# WYOMING ESTATES SUBDIVISION GRADING AND EROSION CONTROL PLAN EL PASO COUNTY, CO

| WYOMING ESTATES SUBDIVISION<br>EL PASO COUNTY, CO                              |                           |  |            |       |  |          |

# ROADWAY PLANS WYOMING ESTATES SUBDIVISION EL PASO COUNTY, CO

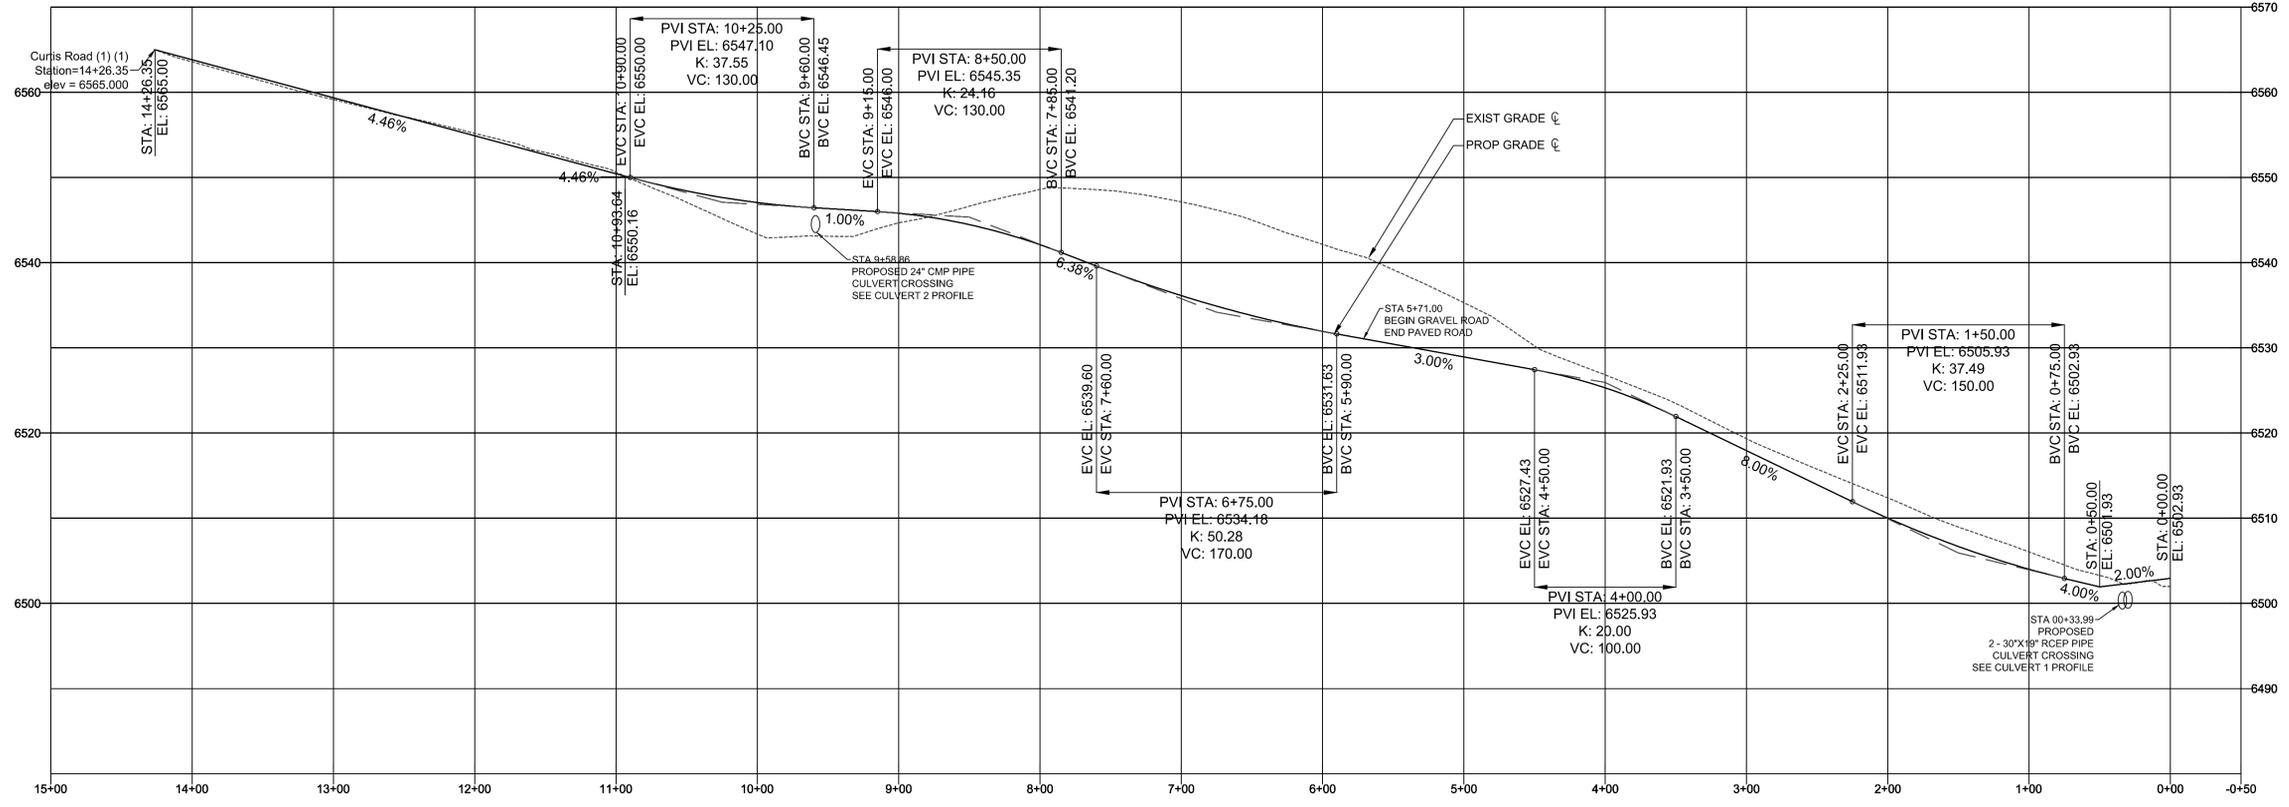
Please relocate this pond to be outside of the ROW preservation.
